SERVICE BULLETIN

NON-MODIFICATION SERVICE BULLETIN - ENGINE - PLATE, RING HPT,
STAGE 2 - CYCLIC LIFE REDUCTION

V2500 Series 72-0682

V2500-ENG-72-0682

LOCATION OF THE STAGE 2 HPT RING PLATE
FIGURE 1

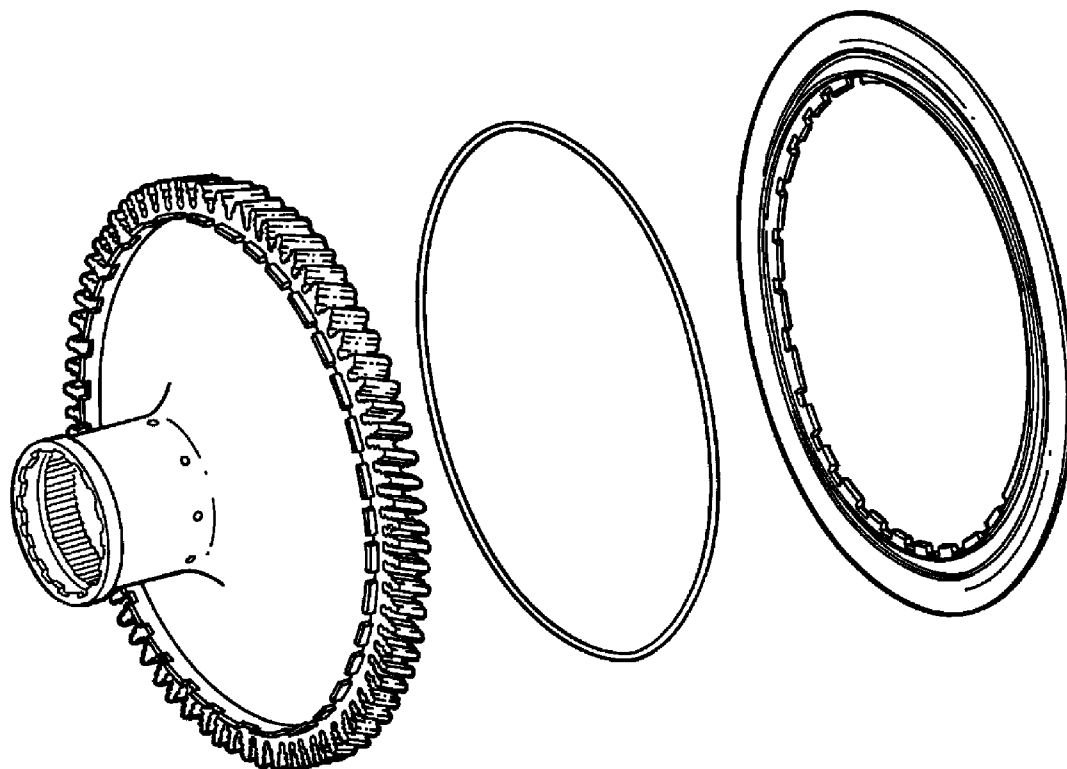
2A3437
HPT STAGE 2 RING PLATE
REPLACE AS SPECIFIED IN
TABLE 1

Accomplish replacement of the HPT Stage 2 Ring Plate, PN 2A3437 identified by serial number and cycle limit specified in Table 1.

Serial Number	Threshold
PKLBJC5331	Replace part prior to accumulating 7081 cycles since new
PKLBJC5369	Replace part prior to accumulating 7479 cycles since new
PKLBML9153	Replace part prior to accumulating 8471 cycles since new
PKLBML9341	Replace part prior to accumulating 7004 cycles since new
PKLBMM8042	Replace part prior to accumulating 6426 cycles since new
